Traffic Analysis Review:

Four Corners Intersection Study
Marin County, CA
DRAFT Report

August 11, 2017

Figure 4. Overhead View of Traffic Patterns, Confusion over ROW during Midday Peak Hour

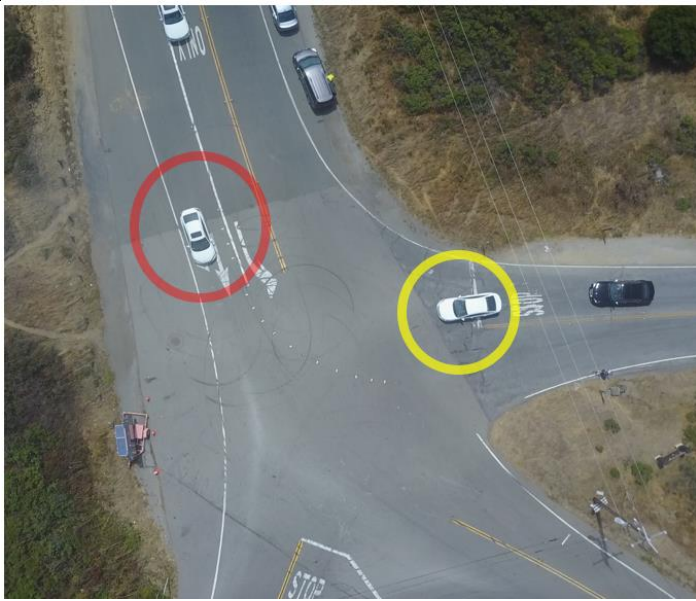
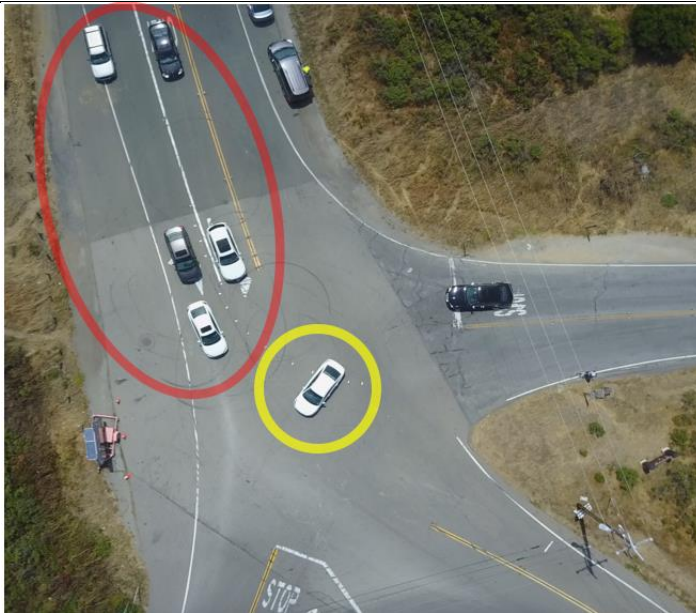
1. The white car on the left in the red circle is the problem car. It stops when it doesn't have to. There is indecisiveness, some confusion about right of way.

2. The white car in the yellow circle is nudging out from Muir Woods Road EB approach even when cars are approaching. This would indicate they don't really know who has the right-of-way, or that they can't see well enough at the stop bar.

3. The vehicle in the yellow circle is causing 5 cars to stop who have the right-of-way. The 5 cars with the right-of-way are not progressing forward into through lane north on Panoramic Highway.

4. As the side street car in the yellow circle continues to slowly (5 mph or less) cross the intersection to Sequoia Valley Road, all other cars are still waiting, then proceed slowly.

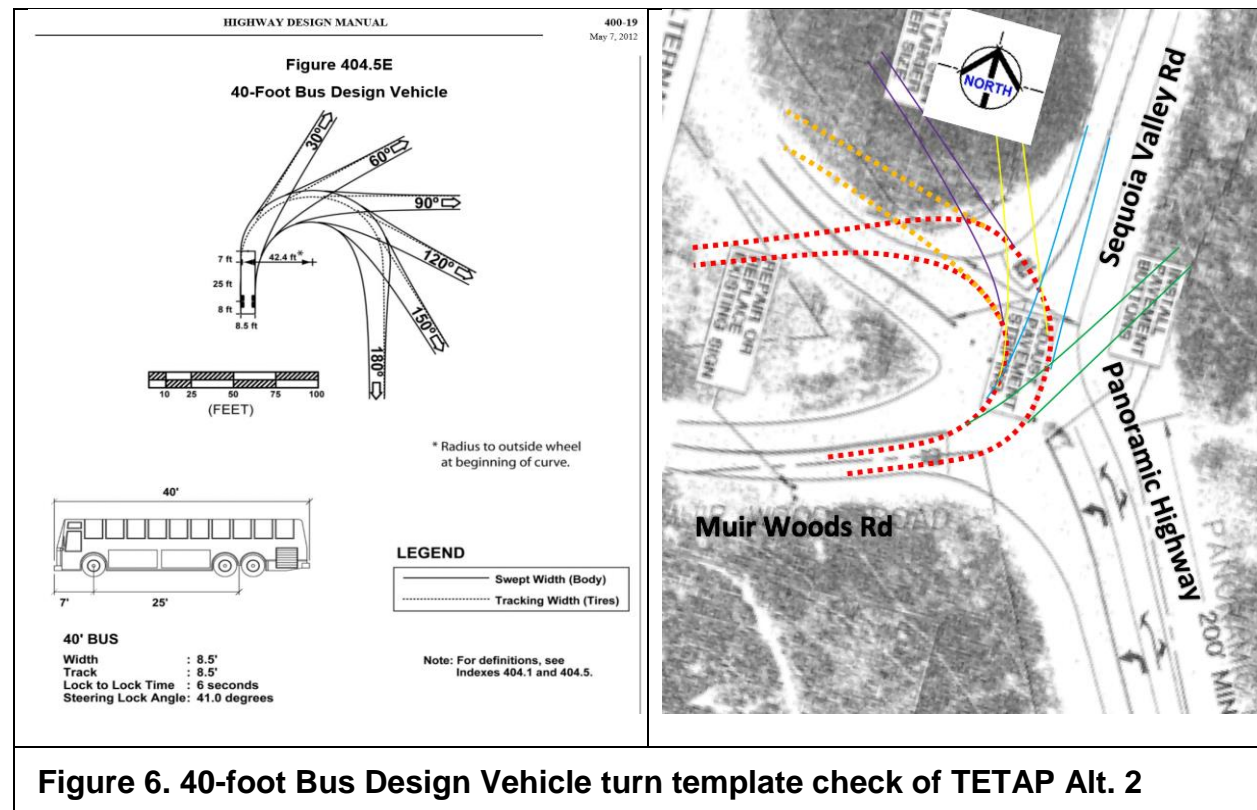
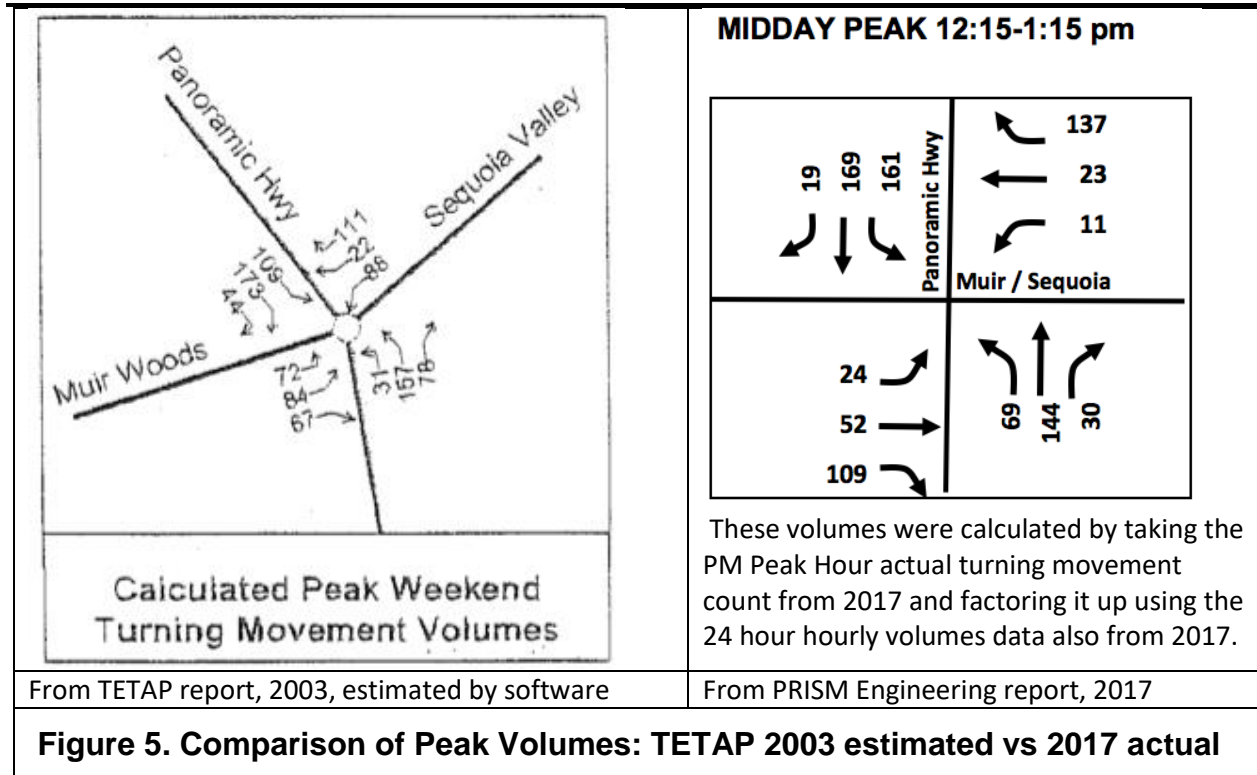
- 1) The traffic analysis procedures used were HCM 2000 methodologies. The manual worksheets contained in the appendix of the TETAP Report show very similar results to the output from Synchro 9 calculated in this report. **Figure 5** shows a comparison of the software generated turning movement volumes from the TETAP report in 2003 (they did not have actual traffic count data at the time and these were estimates based on a software balancing program), and the actual accounts taken by PRISM Engineering in July 2017.

- a. The results of peak traffic in the TETAP report yielded LOS D results (30.5 secs delay avg) for the side street of Muir Woods Road, the worst approach.
 - b. In the PRISM Engineering calculation for midday peak volumes based on actual counts, the numbers differ slightly (see **Figure 5**) but the results are very similar with LOS D for the side street Muir Woods Road EB approach which is currently at LOS D with 27.3 seconds of average delay.
- 2) This is essentially the same result. This is based on both analyses using the same methodology, the Highway Capacity Manual 2000 methods. PRISM Engineering utilized the Synchro 9 software to make this calculation. The TETAP calculation is contained in the appendix of this report..

Figure 9. Alt. 4 Intersection Layout, Striping and Pavement Markings

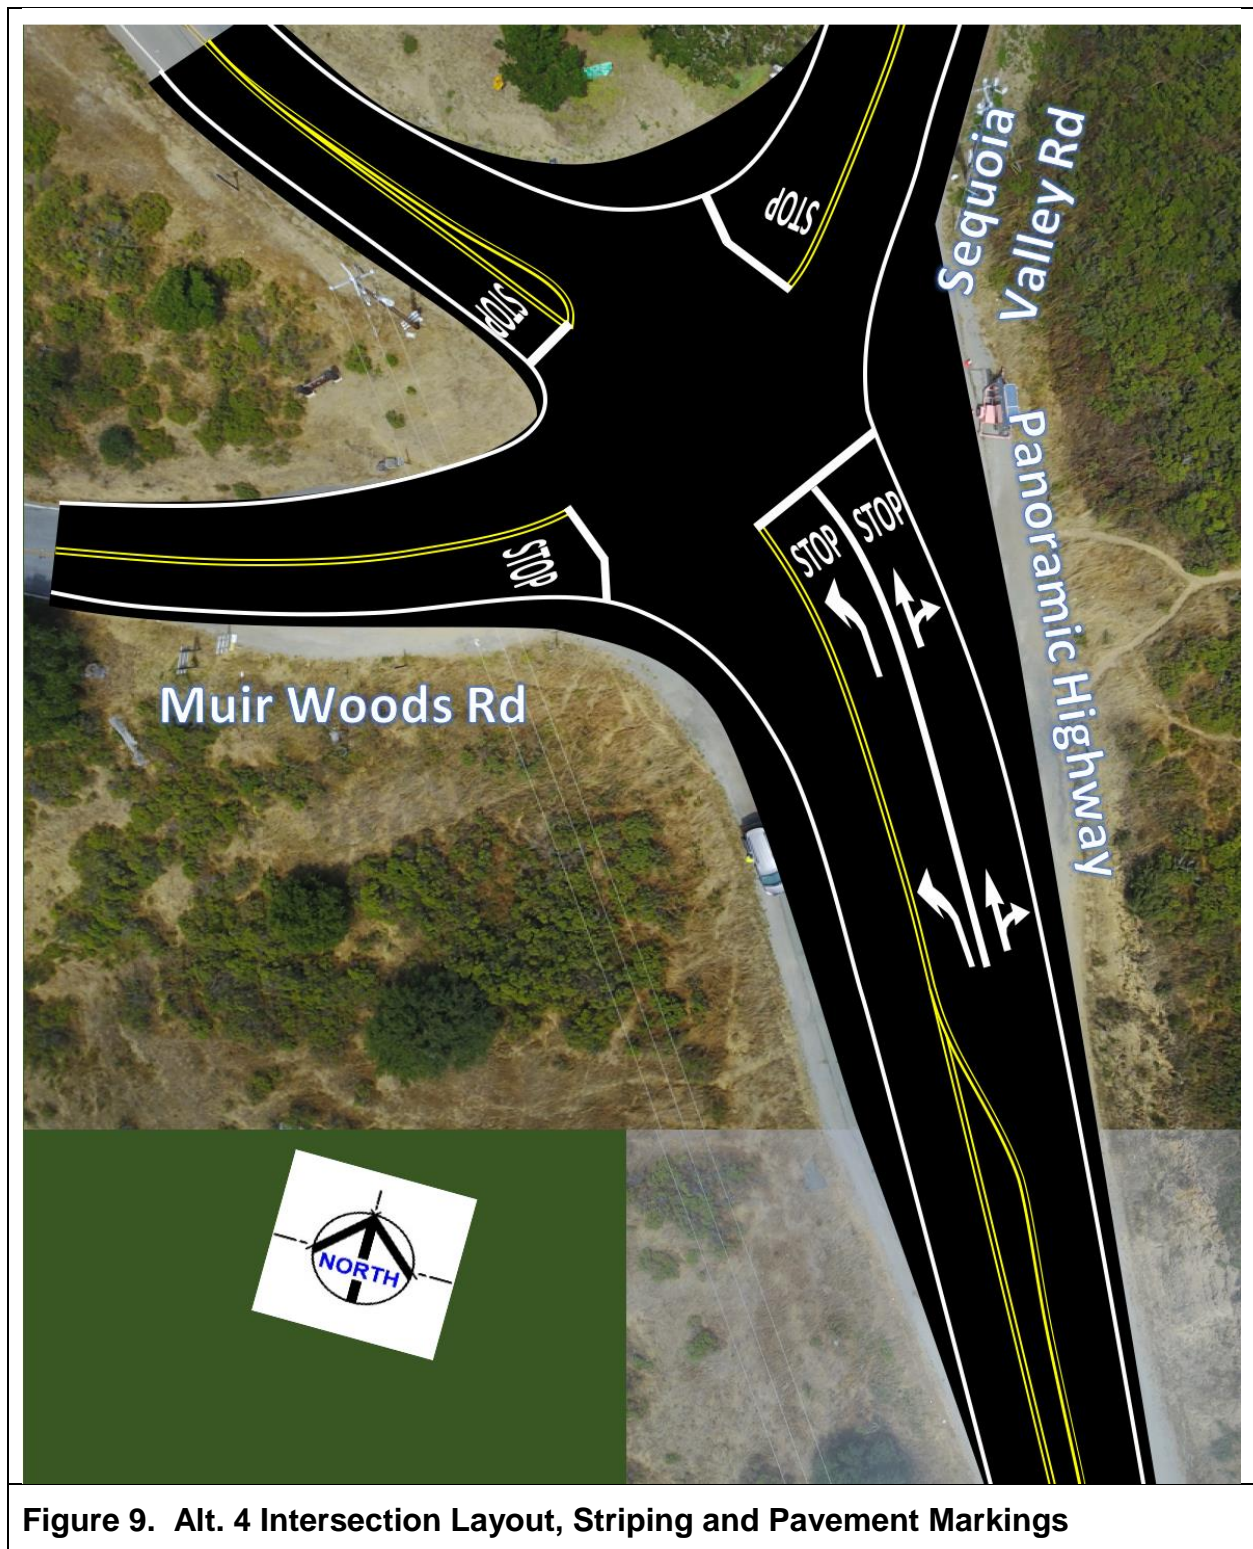
Once these pathway guides shown in **Figure 8** were squared up to be as perpendicular as possible between side street and main street pathways and within existing pavement constraints, PRISM Engineering applied standard MUTCD lane striping and corner edge striping treatments compatible with pathway locations using 12-foot lane widths, as shown in **Figure 9**.

Comparing **Figure 8** to **Figure 9**, it can be seen that the edge line striping has been moved from its original location to accommodate the change in alignment of all approach lanes. The centerline and lane line striping has also been adjusted for the Muir Woods Road eastbound approach to direct traffic towards Sequoia Valley Road, curving left to help eliminate the 60 degree skewed angle. These centerline stripings have also been adjusted for the Panoramic Highway northbound approach, and the Sequoia Valley Road approach. The shifting of the centerlines and adjusting curvature as shown allows for adequate room and setting up lanes to better accommodate the turn moves of large vehicles.

It is recommended that the Alternative 4 design concept configuration shown in **Figure 9** be implemented by Marin County at this intersection. Bicycles will still be obligated to share the road with vehicles (Class III) because of the lack of any road width greater than 24 feet on all streets into and out of this intersection. Pedestrians will also need to share the road as the terrain and topography has trails off street, but local roadways do not have sufficient pavement width or flat ground to install shoulders or sidewalks/pathways for parallel pedestrian traffic. There is some room for parking today, and most of that would remain even with Alternative 4 shifting edge lines to the east.

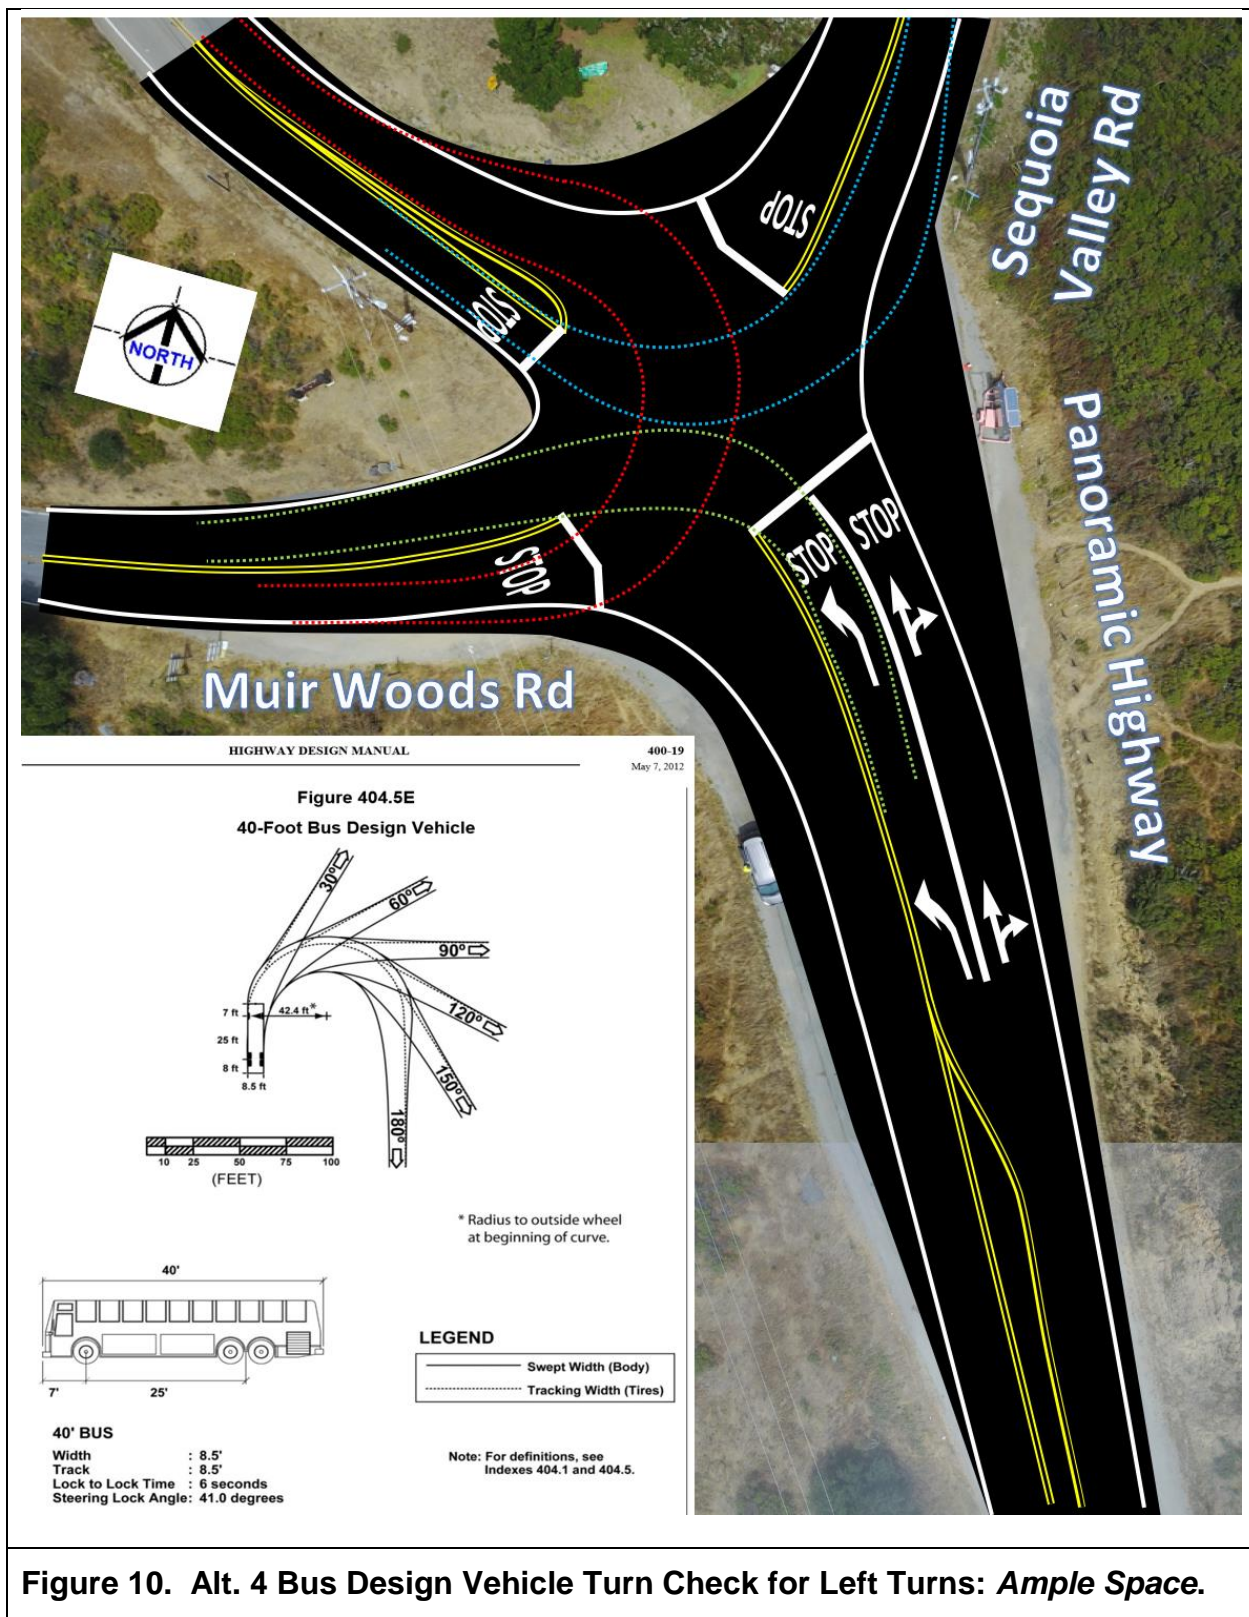
Figure 10 is the proposed Alternative 4 intersection design check using the HDM Figure 404.5E 40-foot bus design vehicle template. Colored dashed lines are overlaid on top of the design concept to illustrate that the 40-foot design vehicle wheels can safely navigate the all left turns within the intersection without encroachment of opposing lanes.
